GOVERNMENT OF MADRAS.
LOCAL AND MUNICIPAL DEPARTMENT.

From J. A. JONES, Esq., MEM. INST. C.E., F.R.S.E., Sanitary Engineer to Government, Madras, to the Chief Secretary to Government, dated Fort St. George, 23rd June 1893, No. 1333.

[Trichinopoly Water-works.]

Approving the proposals of the Sanitary Engineer in connection with the Trichinopoly — scheme.

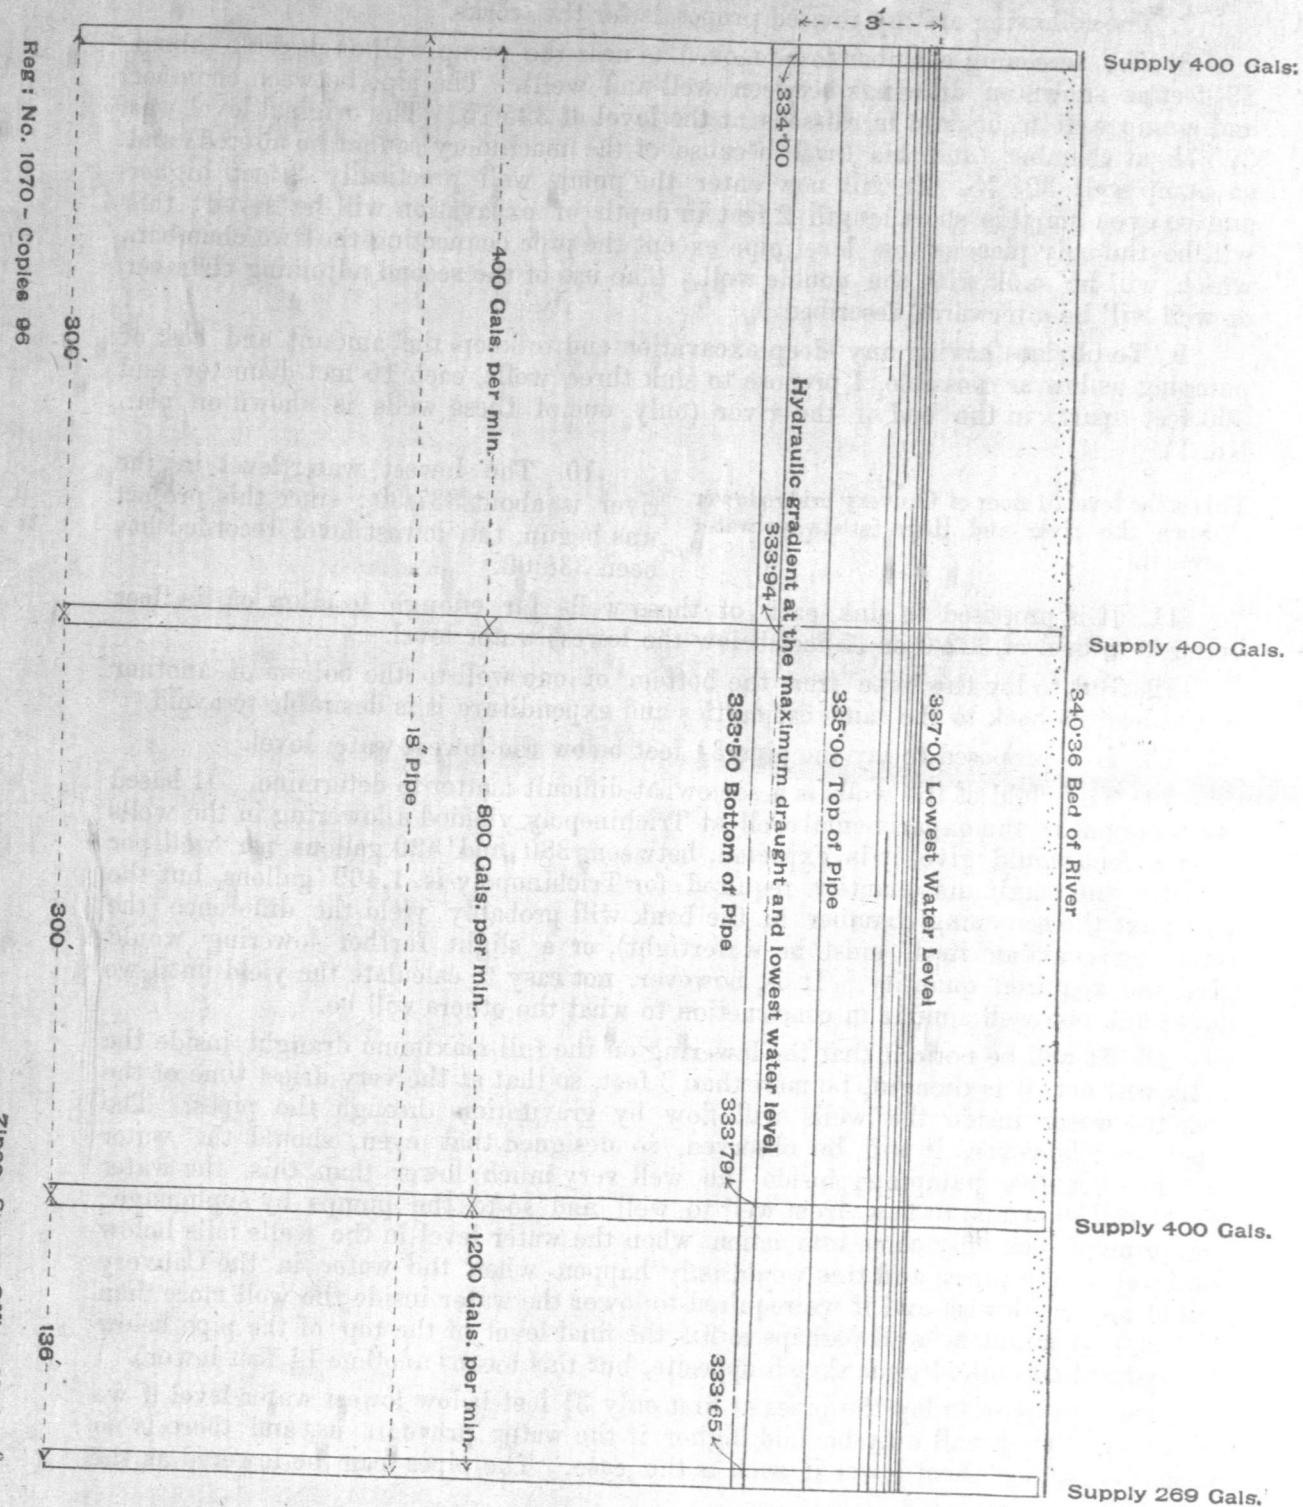
15. It will be noticed that the lowering on the full maximum draught inside the wells will not, it is thought, be more than 3 feet, so that at the very driest time of the year the water inside the wells will flow by gravitation through the pipes. The pipes are, however, it will be observed, so designed that even, should the water fall (by excessive pumping) inside the well very much lower than this, the water would still continue to flow from well to well and so to the pumps by syphonage; this principle can only come into action when the water level in the wells falls below the level of the pipes and this would only happen when the water in the Cauvery was at its very lowest and if we required to lower the water inside the well more than $3\frac{1}{2}$ feet. It might be well perhaps to fix the final level of the top of the pipe below the hydraulic gradient (vide sketch opposite, but this means another $1\frac{1}{2}$ feet lower).

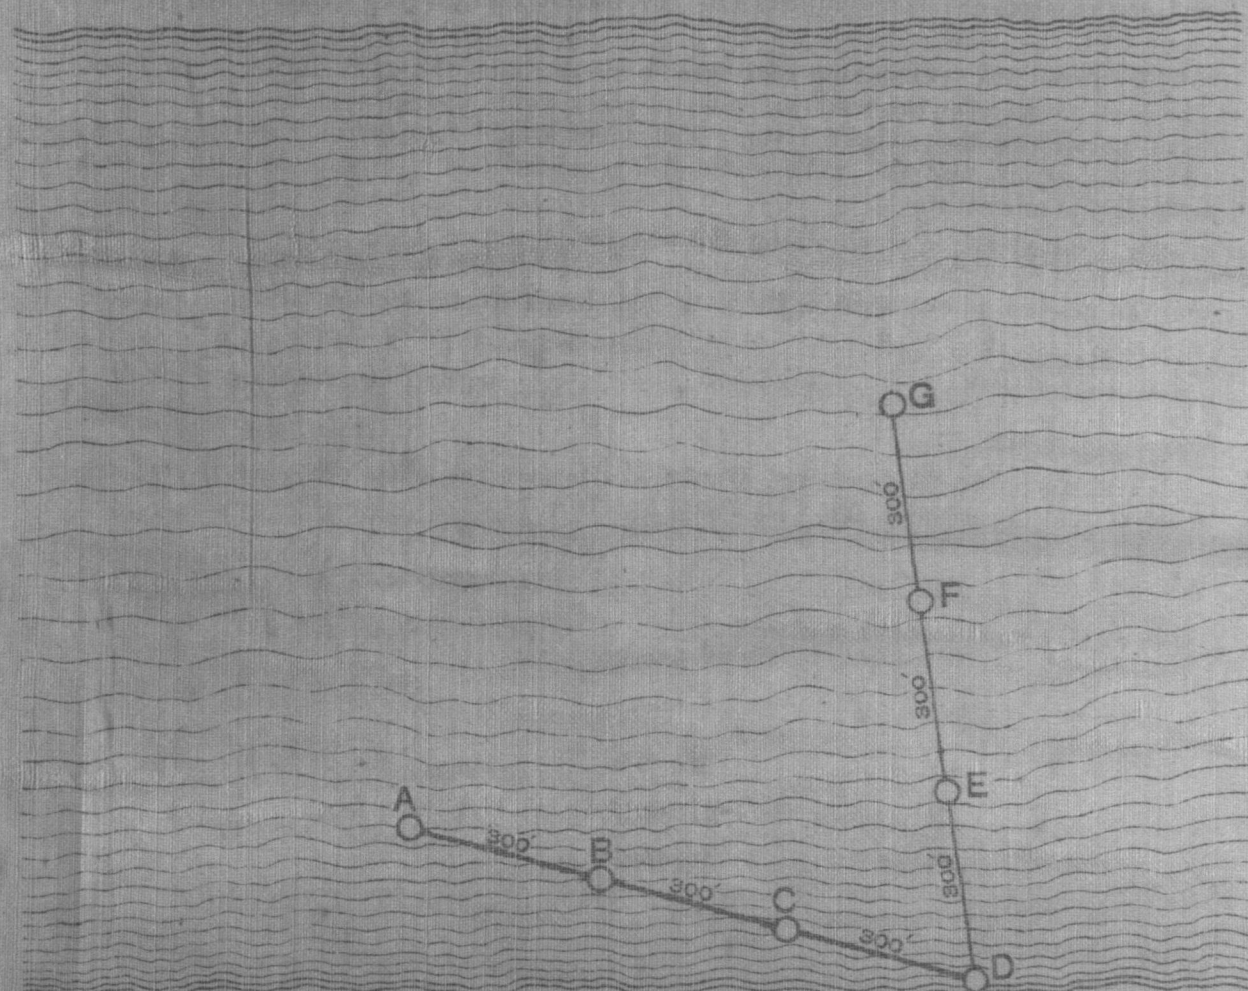
of wells is limited to a certain distance on either side of them; thus, if the wells were placed as per following sketch and if the distance between the wells were in each case 300 feet, the four wells A, B, C, D would probably not yield as much as D and E alone if these were placed as shown somewhat at right angles to the course of the river. If the wells A, B and C were placed further apart so that A was in line with G, the cost of the connecting pipe would be enormously increased.
